PRODUCT CHANGE NOTIFICATION

Bourns HCT Series High Clearance / Creepage Distance Isolation Power Transformers

Modifications and UL Recognition

IC2115

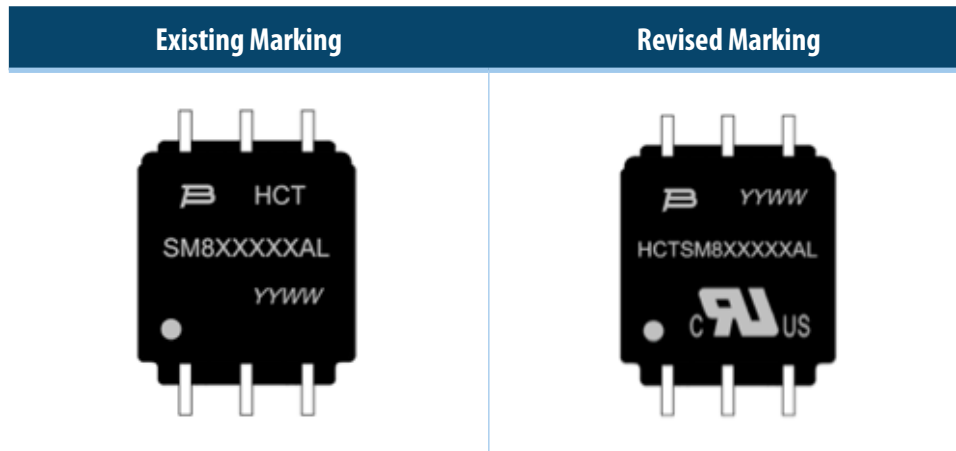
3) The following part numbers are UL Recognized under [File No. E515965](#). The product marking for these part numbers will be modified:

- HCTSM80101AAL, HCTSM80102AAL, HCTSM80201AAL, HCTSM80403AAL, HCTSM80803AAL, HCTSM80809AAL

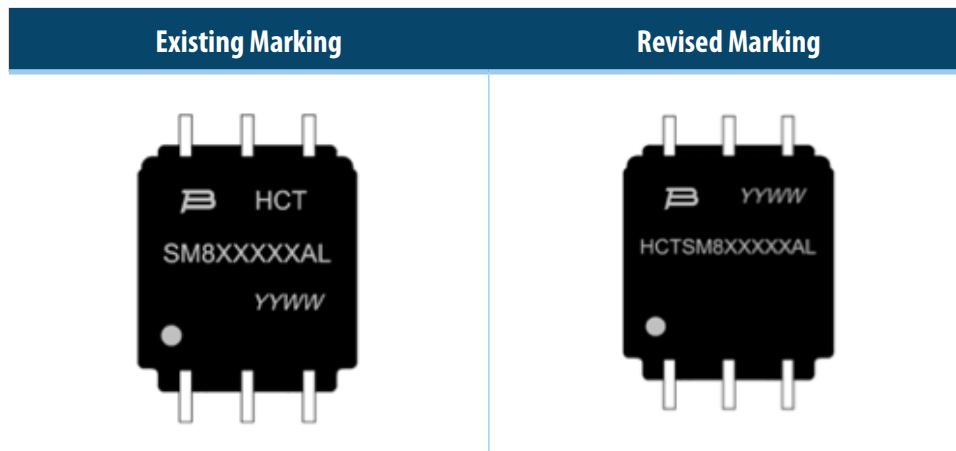
4) The following part numbers are not UL Recognized, but the marking will be modified:

- HCTSM80304BAL, HCTSM80305BAL, HCTSM80308BAL, HCTSM80910BAL, HCTSM81017CAL
